Project	IEEE 802.16 Broadband Wireless Access Working Group < http://ieee802.org/16 >	
Title	Figure 20L Correction and Clarification	
Date Submitted	2005-07-10	
Source(s)	Yair Bourlas, Lei Wang, Cygnus Communications Inc. Mary Chion ZTE	Voice: 760-448-4168 Fax: 760-448-1989 lwang@cygnuscom.com ybourlas@cygnuscom.com
Re:	This contribution provides a correct drawing of Figure 20L for 802.16e.	
Abstract	[Description of document contents.]	
Purpose	The purpose of this contribution is to provide a correct drawing of Figure 20L.	
Notice	This document has been prepared to assist IEEE 802.16. It is offered as a basis for discussion and is not binding on the contributing individual(s) or organization(s). The material in this document is subject to change in form and content after further study. The contributor(s) reserve (s) the right to add, amend or withdraw material contained herein.	
Release	The contributor grants a free, irrevocable license to the IEEE to incorporate material contained in this contribution, and any modifications thereof, in the creation of an IEEE Standards publication; to copyright in the IEEE's name any IEEE Standards publication even though it may include portions o

Figure 20L—Extended subheader format

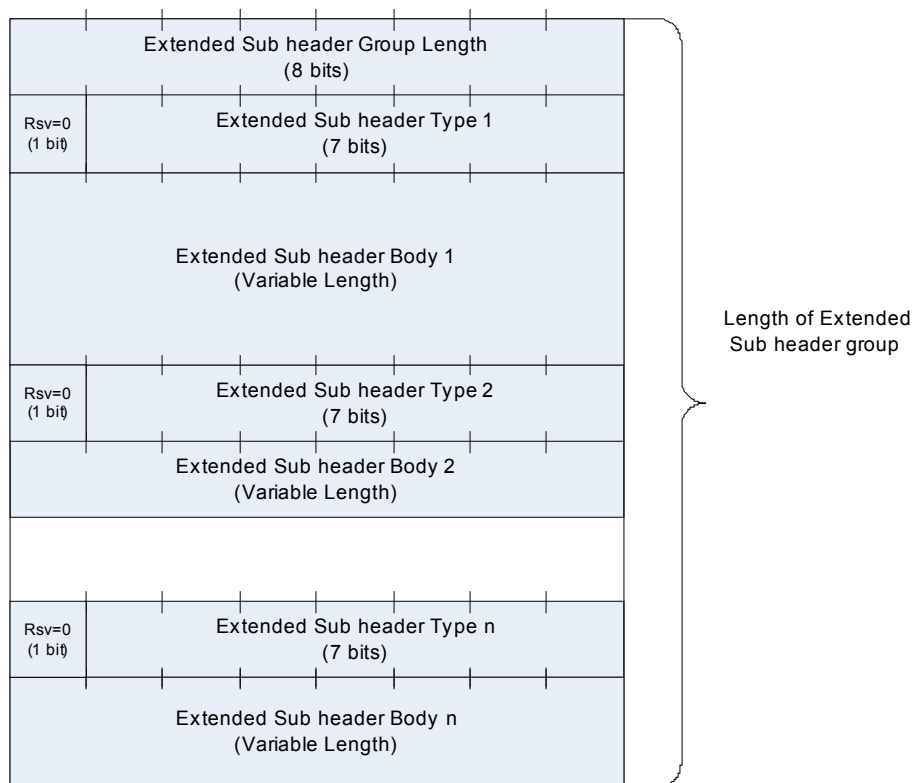
Figure 20L in 16e/D9 needs to be corrected. Clarification text is also added.

In 802.16e/D9, page 32, line 42, replace the Figure 20L by the figure and the paragraph below:

The extended subheader group starts with an 8-bit length field that is followed by one or multiple extended subheaders. The length field specifies the total length in bytes of the subheader group, including all the extended subheaders and the length byte. Each extended subheader consists of a reserved bit, a 7-bit extended subheader type field, and a variable size extended subheader body. The size of each extended subheader is determined by the extended subheader type as specified in Table 13b.
